CITY OF ALBUQUERQUE

Re: Wecks Restaurant
5115 Central Ave Ne
Traffic Circulation Layout
Engineer's/Architect's Stamp 02-17-20 (k17-d025)

Based upon the information provided in your submittal received 02-19-20, the above referenced plan cannot be approved for Building Permit until the following comments are addressed:

Site Plan

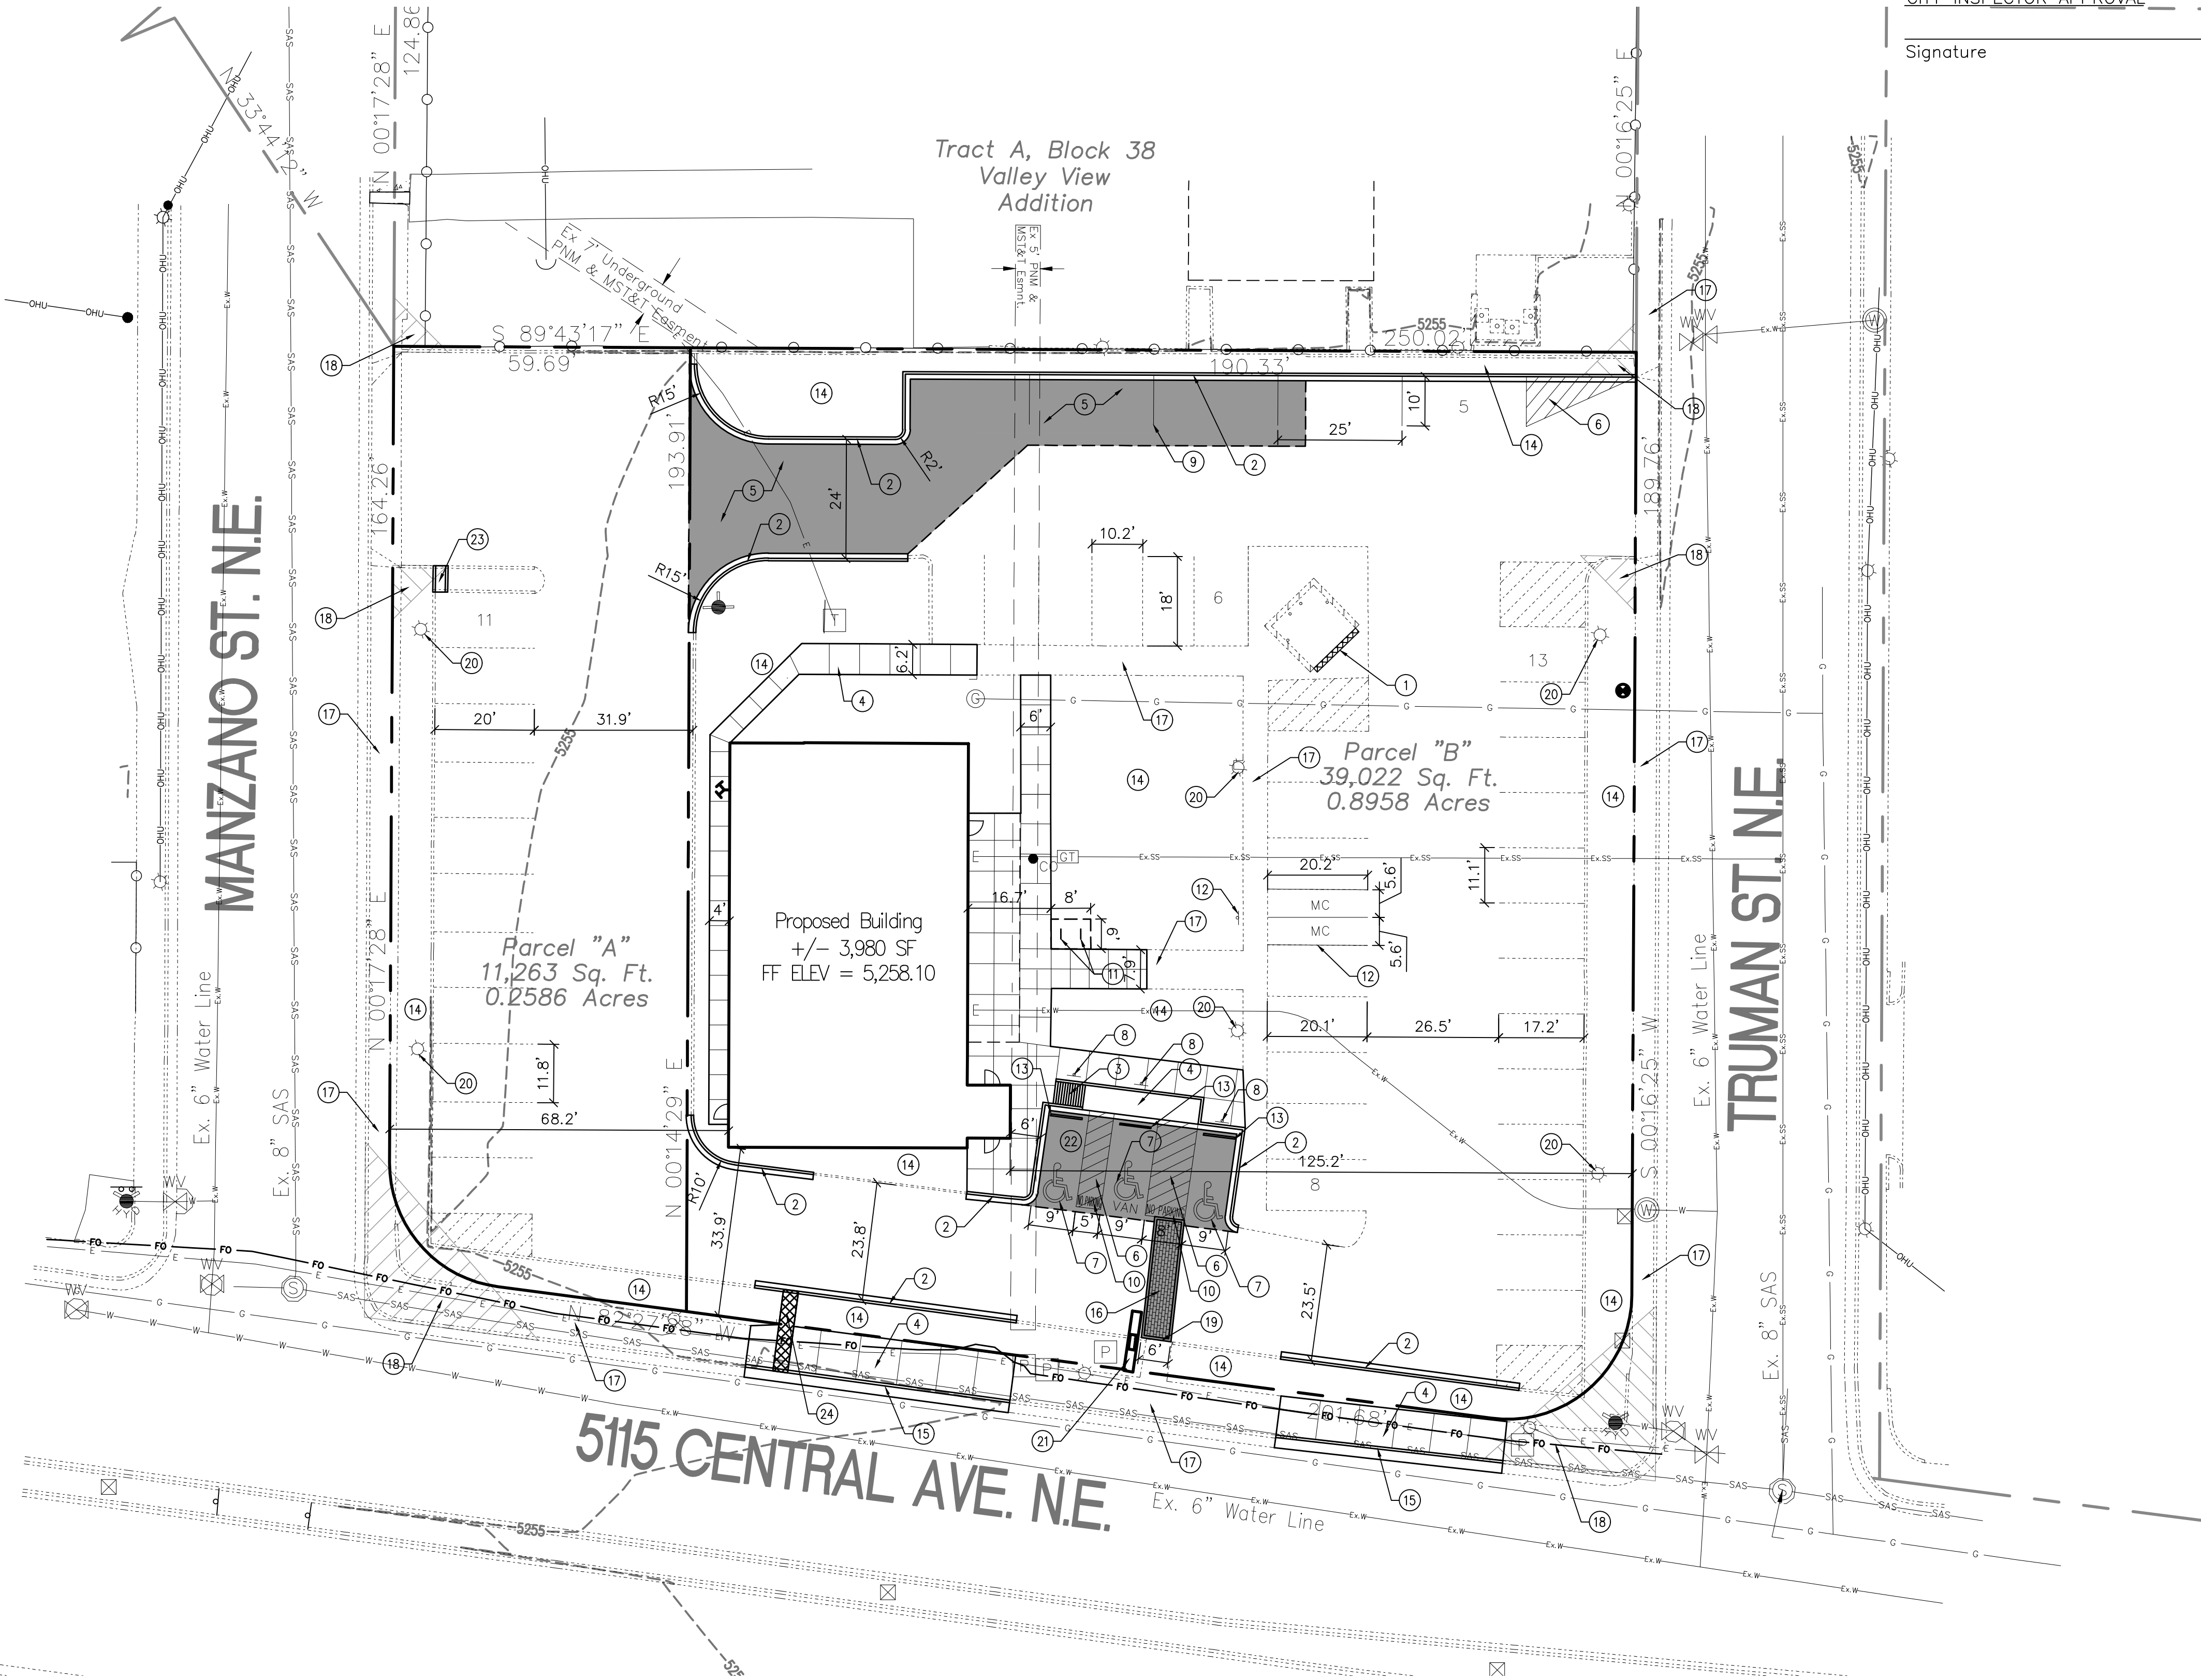
1. Proposed parking calculations need to be coordinated with Zoning.
2. Identify all existing access easements and width dimensions.
3. Please list the length for proposed ADA accessible parking spaces. Some dimensions are not shown.

9. Per the IDO, a 6 ft. wide ADA accessible pedestrian pathway is required from the public sidewalk to the building entrances. Please clearly show this pathway and provide details.

10. Per DPM, a 6 ft. wide ADA accessible pedestrian pathway is required from the ADA parking stall access aisles to the building entrances. Please clearly show this pathway and provide details.

11. ADA accessible pedestrian pathway should not be placed behind parking space or adjacent to a vehicular way. Vehicle and pedestrian/wheel chair conflicts should be avoided as much as possible.

12. All proposed sidewalks and ADA accessible pedestrian pathway dimension/widths need to be shown.
13. Truman Street Driveway: provide a detail of median curb and gutter connection onto existing driveway.

14. Please provide a stopping sight distance exhibit instead of clear sight triangle per DPM chapter 23, Section 3.9.5.
15. Show the clear sight line and add the following note to the plan: "Landscaping and signage will not interfere with clear sight line requirements. Therefore, signs, walls, trees, and shrubbery between 3 and 8 feet tall (as measured from the gutter pan) will not be acceptable in the clear sight line.

16. Please specify the City Standard Drawing Number when applicable.
17. Identify any existing access easement and include a copy of your shared access agreement with the adjacent property owner.

18. Add a note stating "All broken or cracked sidewalk and curb & gutter must be replaced with new sidewalk and curb & gutter." A build note must be provided referring to the appropriate City Standard drawings.

Urban Rack (UB-1000-STD)
NTS

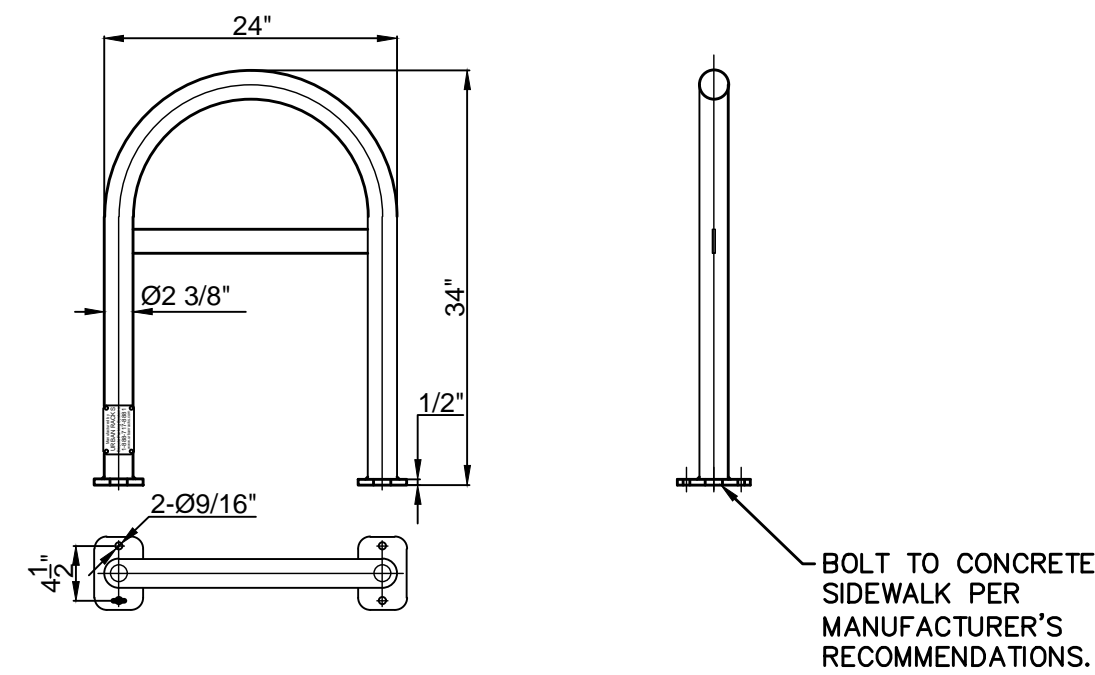
4. ADA curb ramps must be updated to current COA standards or provide detail.
5. All bicycle racks shall be designed according to the following guidelines:

- a. The rack shall be designed to support the bicycle in an upright position. See the IDO for additional information.
 - b. The rack allows varying bicycle frame sizes and styles to be attached.

- c. The user is not required to lift the bicycle onto the bicycle rack.
 - d. Each bicycle parking space is accessible without moving another bicycle.

6. Bicycle racks shall be sturdy and anchored to a concrete pad.
7. A 1-foot clear zone around the bicycle parking stall shall be provided.
8. Bicycle parking spaces shall be at least 6 feet long and 2 feet wide.
